MODERNIZATION AT CURRAN MIDDLE SCHOOL FOR:

MARK	DATE	DESCRIPTION
SD		
CD		
01	06/23/07	ADDENDUM 1
02	09/11/07	ADDENDUM 2
03	11/01/07	ADDENDUM 3

SHEET TITLE
INTERIOR ELEVATIONS BUILDINGS B & C

SHEET IDENTIFICATION NUMBER
A-233
SHEET 22 OF 46

C1 TYPICAL CLASS ROOM CONT.
1/4"=1'-0"

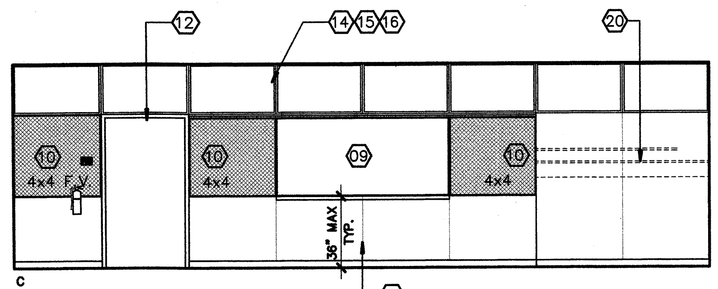
Item No. 11: Refer to Sheet A-233
Interior Elevation "C1" Elevation "D" Sink cabinet to be made accessible, replace existing sink cabinets with (WIC 155) all references to sink cabinet modification to be deleted. Revise Keynote #02 to read. "Remove and replace existing counter top with corian countertop with 6" splash (unless noted otherwise) calk to wall typical." Revise Keynote 03 to read. "Replace existing sink cabinet with ADA compliant sink cabinet, typical all sink cabinets." Revise Keynote #4 to read. "Existing cabinet to remain, remove and replace all doors, drawer fronts, & face plates." Finish per specifications." Revise Keynote #18 to read. "Remove existing trough sink, provide install corian counter with 6" splash & accessible sink per plumbing plans. See addendum drawing ADD-007 for further requirements." Delete Keynote #19.
